REFERENCE NHSTA RECALL # 14E009

VILLA INTERNATIONAL				
ABTS HINGE LINK, RECALL INSPECTION				
JGM 4.28.14	SIZE	FSCM NO.	DWG NO.	REV
	SCALE		01

VILLA INTERNATIONAL				
ABTS HINGE LINK, RECALL REPAIR				
JGM 4.21.14	SIZE	FSCM NO.	DWG NO.	REV
	SCALE		02

VILLA INTERNATIONAL
RECALL REPAIR 14E-009

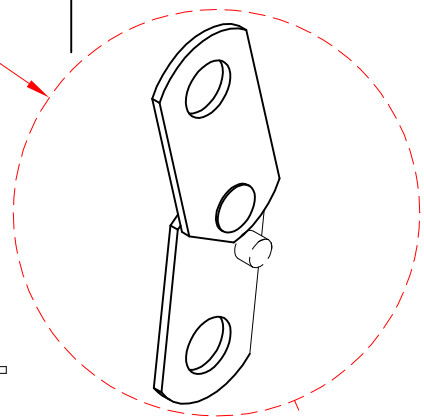
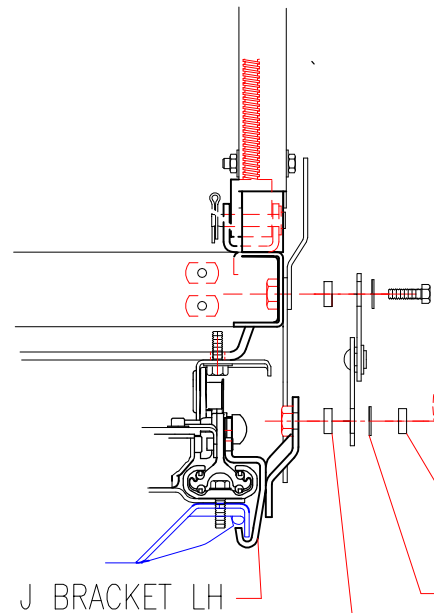
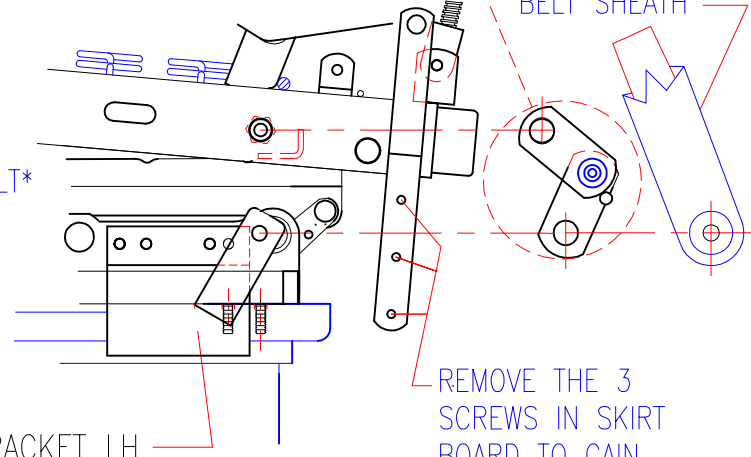
ABTS HINGE LINK SHOWN INSTALLED INCORRECTLY WHEN THE LOWER LINK IS INBOARD TOWARD THE SEAT FRAME.

NOTE:
 THIS REPAIR IS INTENDED ONLY FOR THOSE ABTS HINGES INSTALLED INCORRECTLY AS SHOWN IN THE LH SIDE VIEW.
 * IDENTIFIES REPAIR KIT HARDWARE.
 REMOVE TWIST IN SEAT BELT BEFORE INSTALLING SHEATH AND FASTENING END.
 TIGHTEN REPLACEMENT BOLT TO 20 FT-LB.
 LEFT SIDE OF DRIVERS SEAT SHOWN
 RIGHT SIDE PASSENGER SEAT THE SAME.

REMOVE THE 3 SCREWS IN SKIRT BOARD TO GAIN ACCESS TO LINK BOLT.

CORRECT INSTALLATION
OF THE ABTS HINGE LINK.

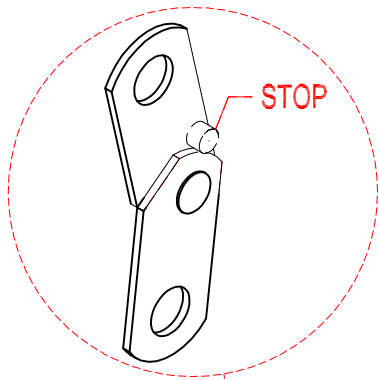
THE ABTS HINGE LINK IS INSTALLED
CORRECTLY
WHEN THE UPPER LINK WITH THE STOP IS
TOWARD THE SEAT FRAME AND THE LOWER
LINK IS OUTBOARD FROM THE SEAT FRAME.
NO REPAIR IS REQUIRED.

INCORRECT INSTALLATION
OF THE ABTS HINGE LINK.

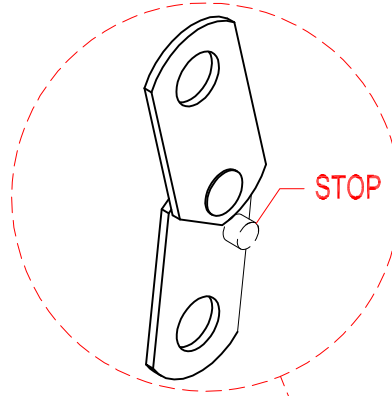
THE ABTS HINGE LINK IS INSTALLED
INCORRECTLY
WHEN THE UPPER LINK IS
OUTBOARD FROM THE SEAT FRAME AND THE
LOWER LINK WITH THE STOP IS INBOARD FROM
THE SEAT FRAME.
USE REPAIR KIT 14E-009T/B FOR REPAIR.
